PRELIMINARY SITE PLANS FOR
ROCHESTER RETAIL
 N.E.C. OF ROCHESTER ROAD AND AVON ROAD
 CITY OF ROCHESTER HILLS, OAKLAND COUNTY, MICHIGAN

Site Plan Review		
Reviewed for compliance to the City Ordinance, Building and Fire Codes		
Department	Reviewer	Approved
Planning	Kristen Kapelanski 248-841-2772 KapelanskiK@RochesterHills.org	Yes
Building	Mark Artinian 248-841-2446 ArtinianM@RochesterHills.org	Yes
Engineering	Jason Boughton 248-841-2490 BoughtonJ@RochesterHills.org	Yes
Nat. Resources	Matt Einheuser 248-841-2551 EinheuserM@RochesterHills.org	Yes
Fire	Lt. Ann Echols 248-841-2701 EcholsA@RochesterHills.org	Yes

Conditions and mark-ups noted throughout the plan set must be addressed prior to final approval.

DRAWING TITLE
COVER SHEET

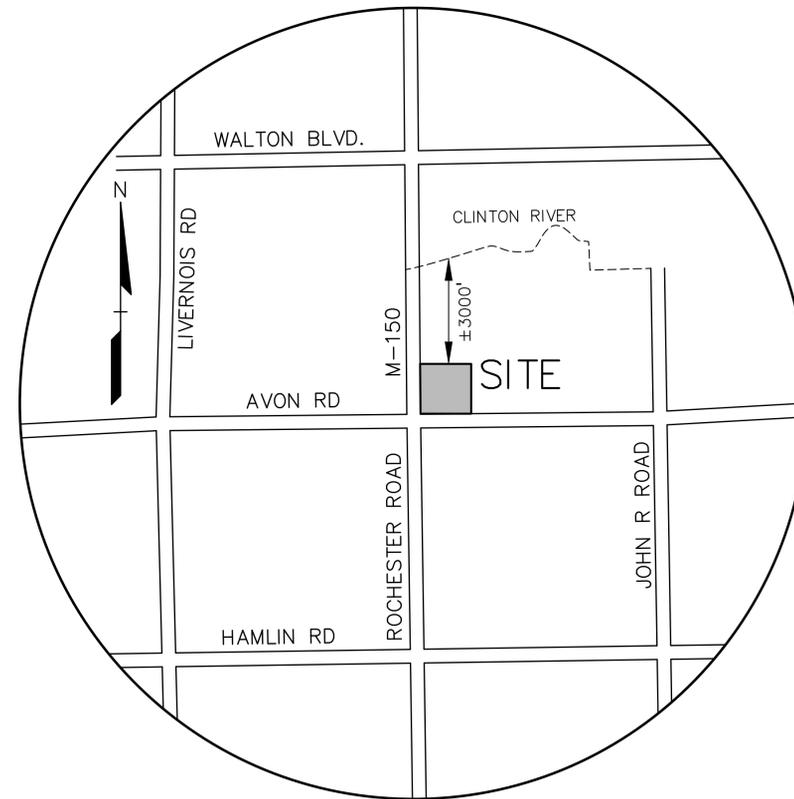
NOTE:
 A CONDITIONAL USE PERMIT IS
 REQUIRED FOR THE DRIVE-THROUGH

Refer to Section 138-1.203 of the Zoning Ordinance for conditional use signage requirements. Signs advertising a conditional use is proposed for the property must be posted 15 days prior to the public hearing.

DRAWING TITLE
TOPOGRAPHIC SURVEY

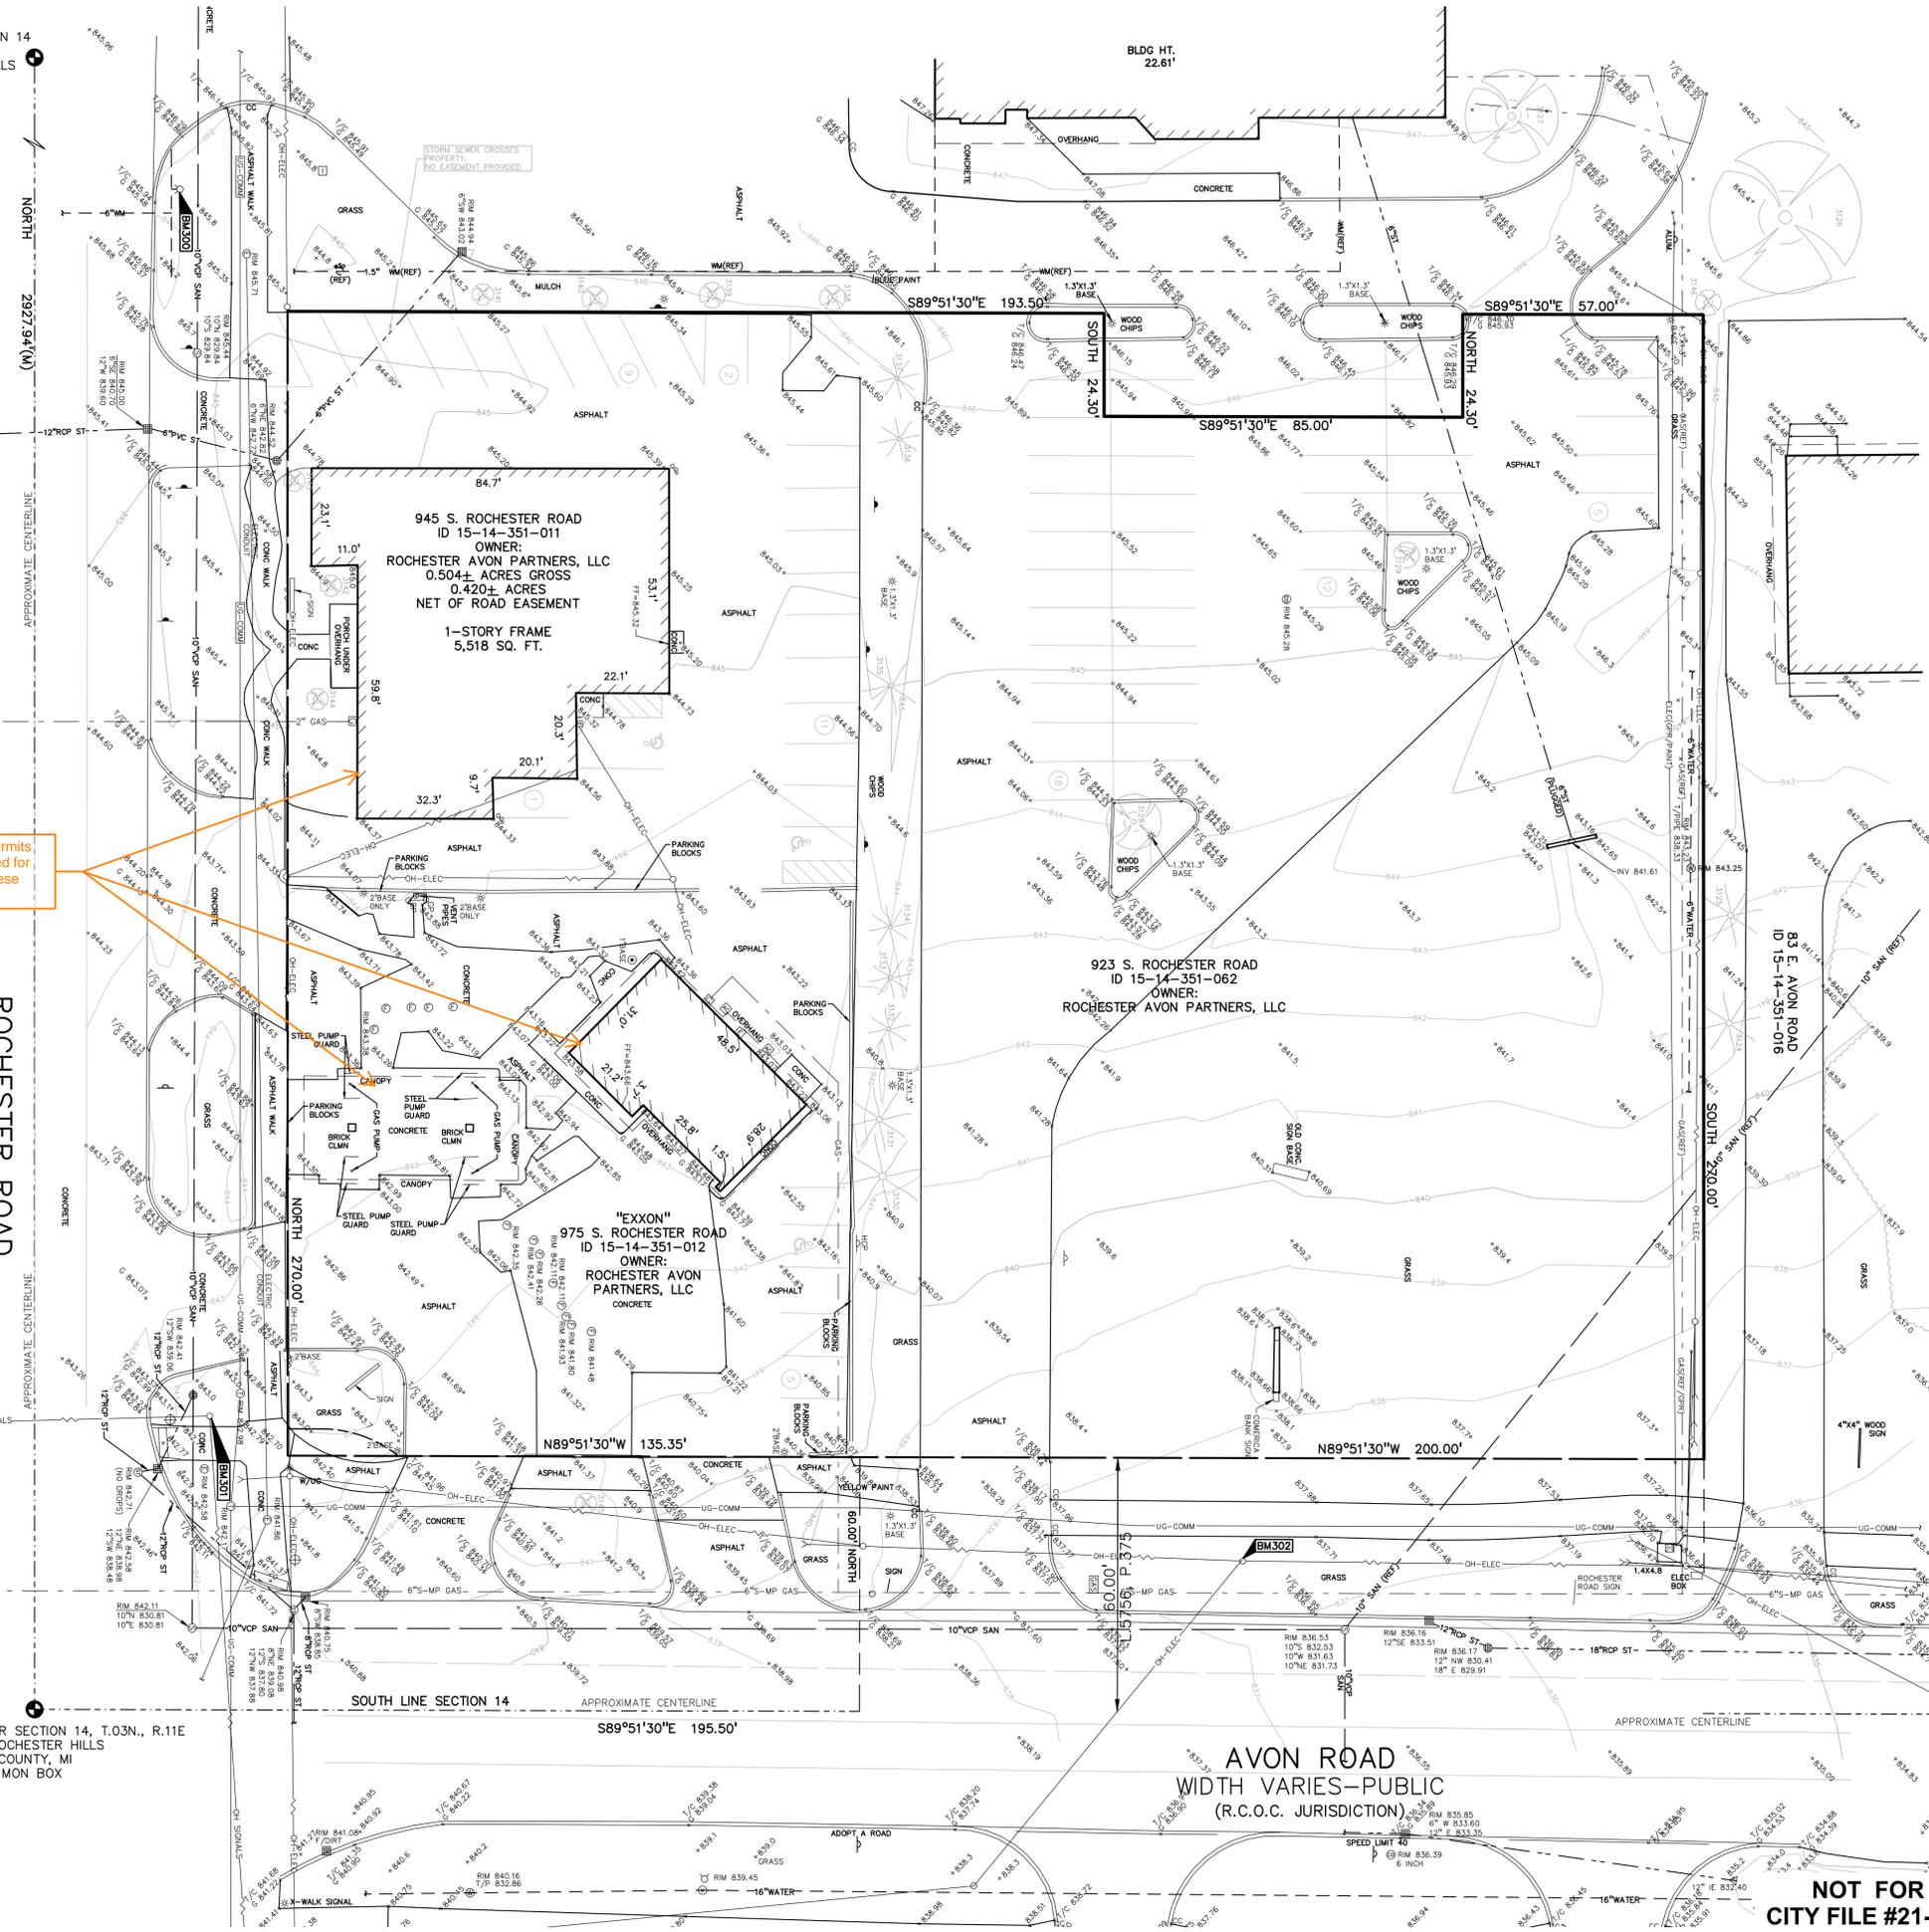
Demolition permits will be required for removal of these structures.

DRAWING TITLE
PRELIMINARY UTILITY PLAN - EAST

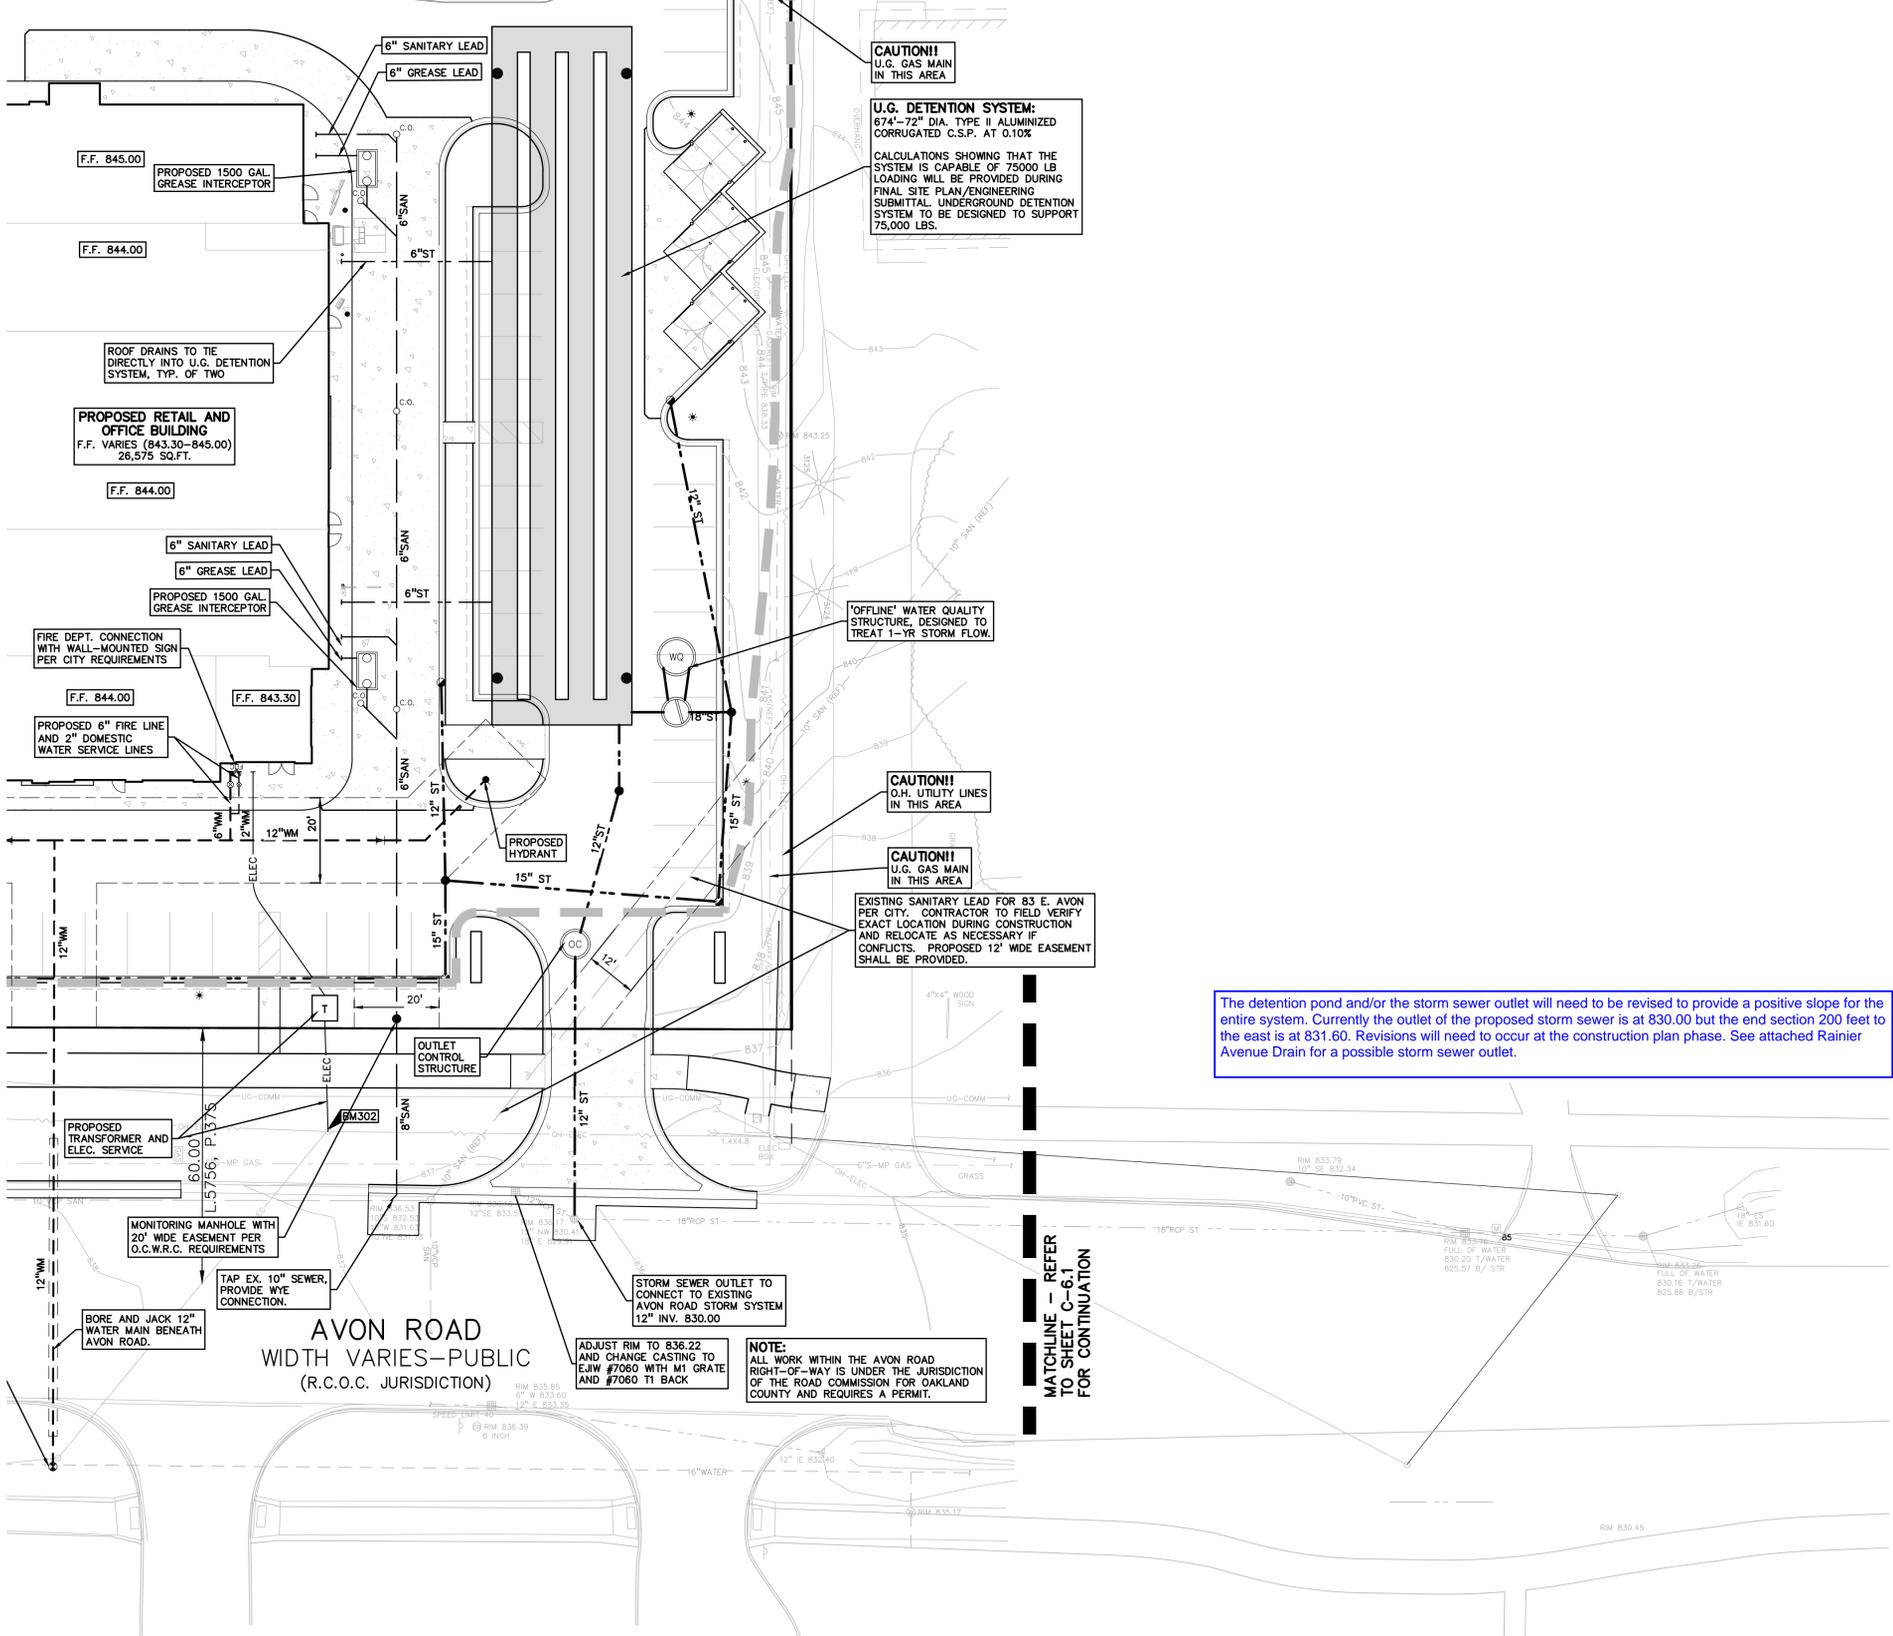
The detention pond and/or the storm sewer outlet will need to be revised to provide a positive slope for the entire system. Currently the outlet of the proposed storm sewer is at 830.00 but the end section 200 feet to the east is at 831.60. Revisions will need to occur at the construction plan phase. See attached Rainier Avenue Drain for a possible storm sewer outlet.

ORIGINAL ISSUE DATE:
MAY 10, 2021
DRAWING TITLE
LANDSCAPE PLAN

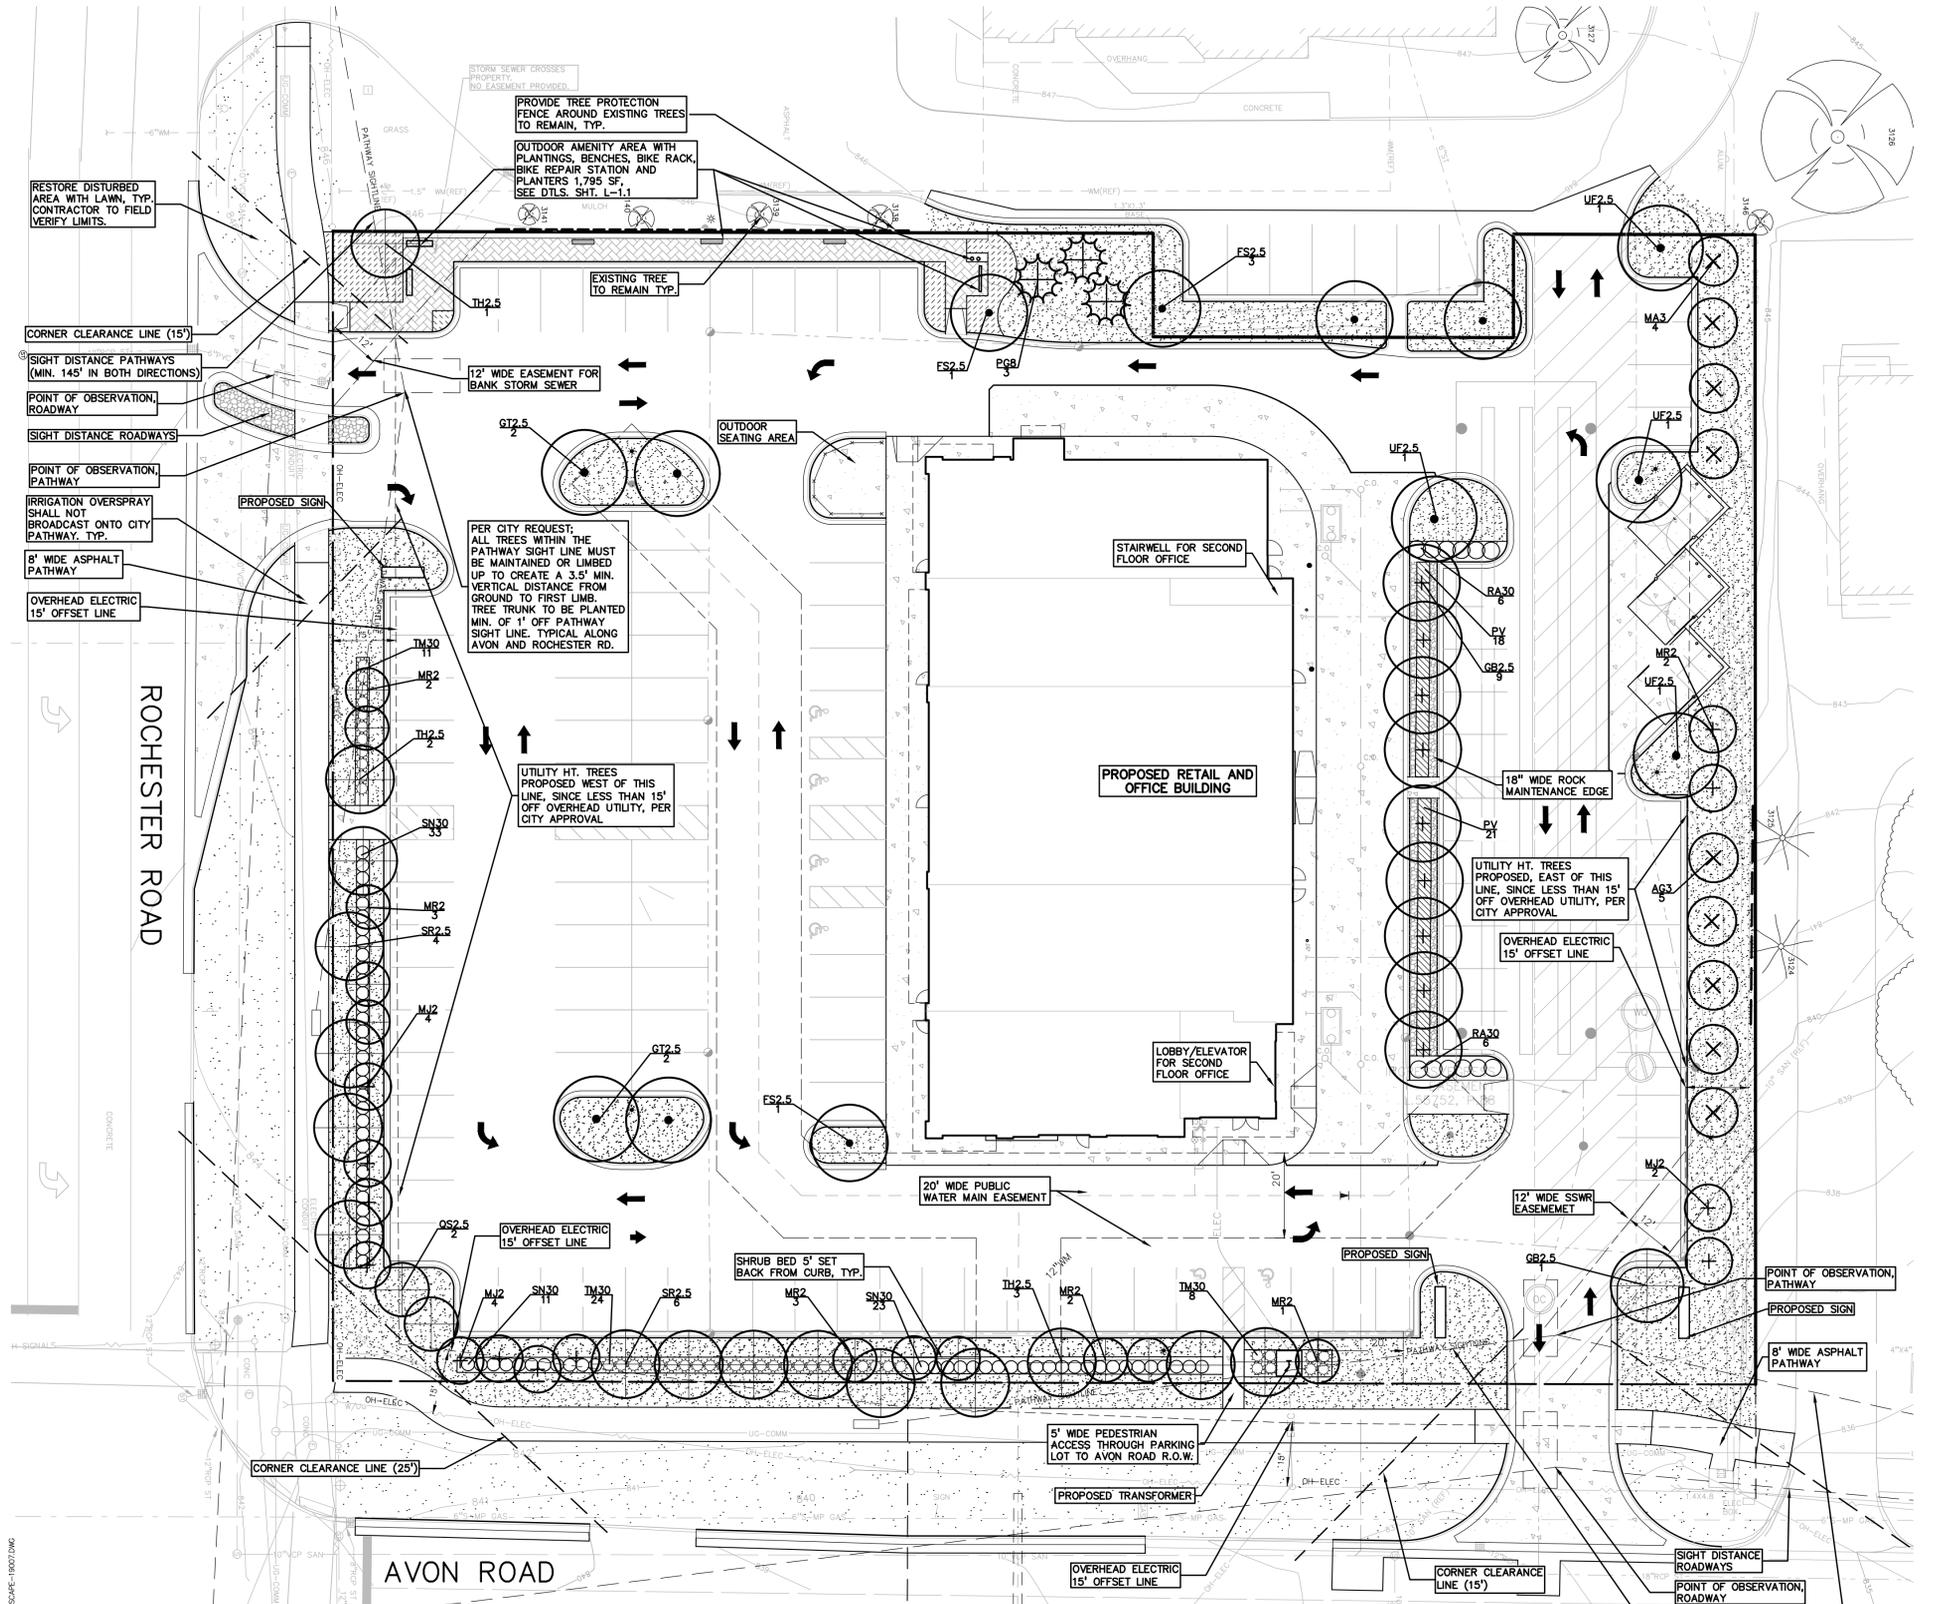
Add note: Irrigation overspray shall not broadcast onto the City pathway.
